WIRELESS SET NO. 19
MODIFICATION INSTRUCTIONS INDEX

WIRELESS SET NO. 19

Reduction in output level of 'B' set using Control unit No. 10

TECHNICAL HANDBOOK - MODIFICATION INSTRUCTION

Fig. 1 - Modification to Control unit No. 10, when
used with Wireless set No. 19

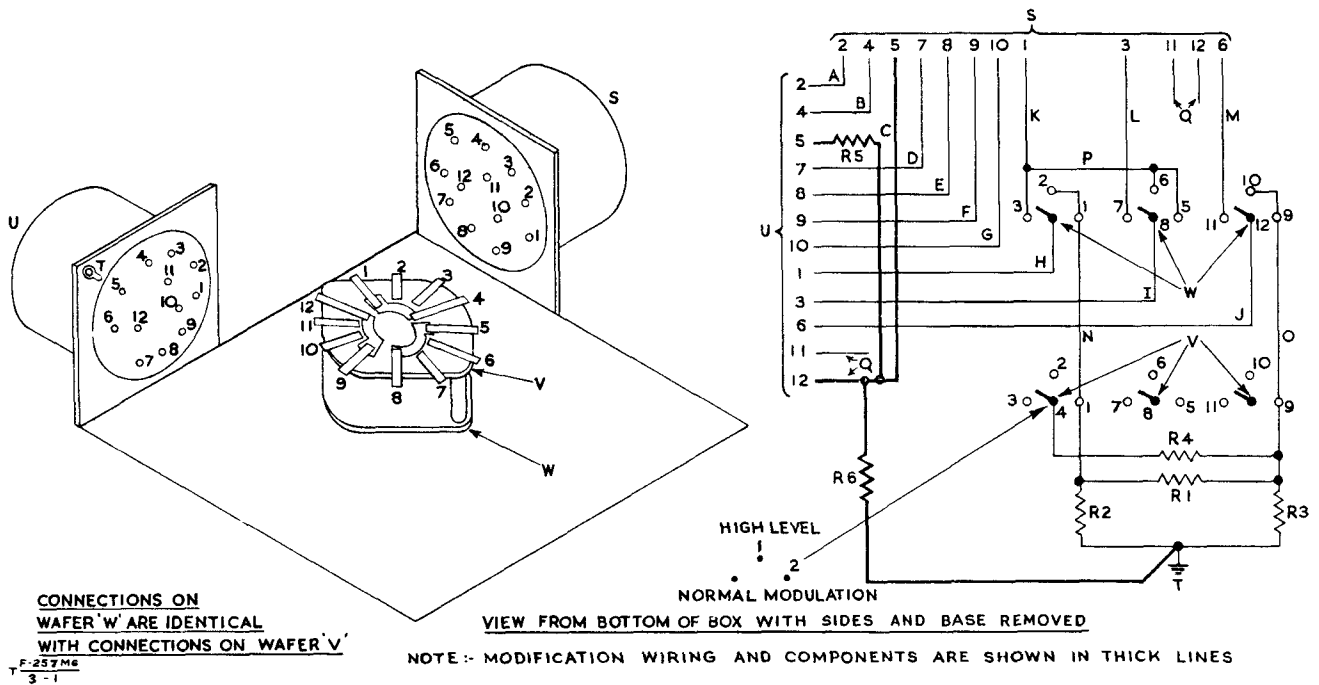
- 1. On certain installations of the Wireless set No. 19, using Control unit No. 10, a high pitched whistle is experienced, notably when sending with a Control unit No. 2 switched to R - A and B. This is caused by the high level of side-tone on the Wireless set No. 19, 'B' set. It can be prevented by reducing the output level of the 'B' set by connecting a 47Ω resistor in series with the 'B' set output and another 47Ω resistor in parallel with the lead to the phones.

- 6. (a) Open the Control unit No. 10 and refer to Fig. 1
- (b) Disconnect the wire from pin No. 5 of the 12-point plug on the side of the unit (Plug U) and reconnect to pin No. 12.
- (c) Connect a 47Ω resistor pin No. 5 and pin No. 12.
- (d) Connect a 47Ω resistor between pin No. 12 and the solder tag (T) already fitted beneath one of the securing screws of the 12-point plug.
- (e) Paint a $\frac{1}{2}$ in. square with red paint on the top of the Control unit No. 10.
- (f) Check the operation of the control unit.
- (g) Particular attention should be paid when performing this modification to ensure that the resistors are connected to the correct socket.

Connector ref.	Connections	Colour	Length	Connector ref.	Connections	Colour	Length
A	U2 - S2	B	5 in.	L	W7 - S3	C	5 in.
B	U4 - S4	A	5 in.	M	W11 - S6	C	5 in.
C	U5 - S5	B	5 in.	N	W2 - W1 - V1	B	3 in.
C (after Modification)	U12 - S5	B	5 in.		W10 - W9 - V9	B	3 in.
D	U7 - S7	A	5 in.	P	W3 - W5 - W6	B	3 in.
E	U8 - S8	B	5 in.	Q (before modification)	No connections		
F	U9 - S9	C	5 in.	R1	V1 - V9, 4,700Ω	1W resistor	
G	U10 - S10	A	5 in.	R2	V1 - T, 100Ω		
H	U1 - W4	A	5 in.	R3	V1 - T, 100Ω		
I	U3 - W8	C	5 in.	R4	V4 - V9, 10,000Ω		
J	U6 - W12	C	4 in.	R5 (after modification)	U5 - U12, -47Ω		
K	W3 - S1	A	4 in.	R6 (after modification)	U12 - T, 47Ω

Fig. 1 - wiring diagram

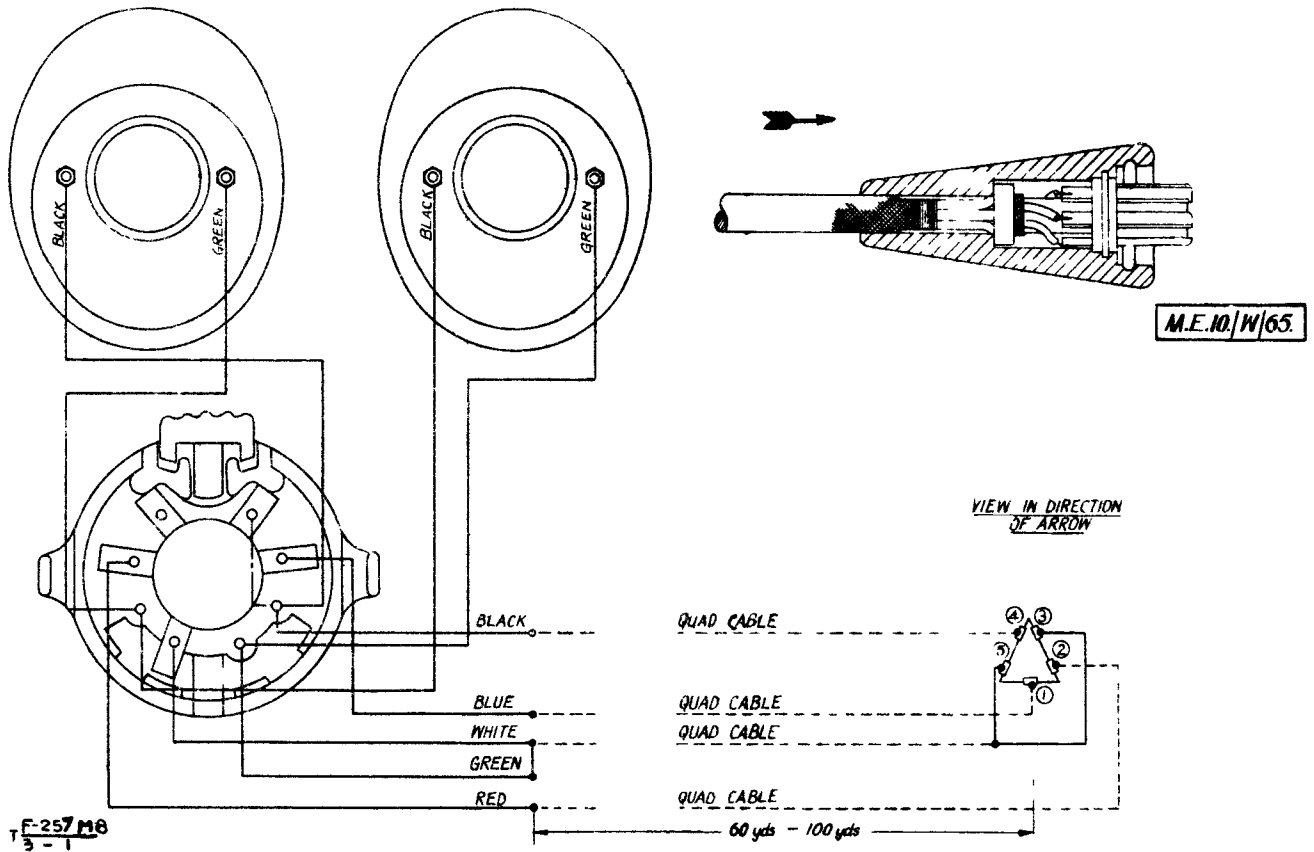
- (b) Connect Microphone and receiver headgear assembly No. 10 to the quad cable as shown in Fig. 1., leaving the connections bare.
- (c) Connect the 5-point plug No. 5 to the other end of cable, as shown in Fig. 1 and Table 1, and test with an Avometer or buzzer to ensure correct assembly.
- (d) Insert 5-point plug No. 5 into the Commander's drop lead socket and test efficiency of system. If a howl is experienced in the headphones on any of the services ('A', 'B', 'I.C'., or re-broadcast), disconnect 5-point plug from quad cable and reduce length of cable to 60 yd. Reconnect 5-point plug and re-test.
- (e) If the system is satisfactory either with 100 or 60 yd. of quad cable, bind individual leads and final joint at microphone and receiver headgear end with insulating tape and apply shellac, Bostik 'C' or bakelite varnish to ensure waterproof joint.

- (a) Remove the bonding between the white and green leads at the microphone and receiver end, and between pins 3 and 5 at the 5-point plug end.
- (b) Connect a single strand of D.3 cable to pin 5 of the 5-point plug No.5, and bind this cable to the quad with twine at intervals of 2 yd.
- (c) Connect the other end of the D.3 cable to the green lead at the microphone and receiver headgear end. The connections should be as shown in Table 2.

Microphone and receiver headgear No. 10 (colour of leads)	5-point plug No. 5, locking into plug (see arrow in Fig. 1)
Blue	Pin 1
Red	Pin 2
White } Bonded	Pin 3 } Bonded
Green } Bonded	Pin 5 } Bonded
Black	Pin 4

Microphone and receiver headgear No. 10 (colour of leads)	5-point plug No. 5, locking into plug (see arrow in Fig. 1)
Blue	Pin 1
Red	Pin 2
White	Pin 3
Black	Pin 4
Green	Pin 5
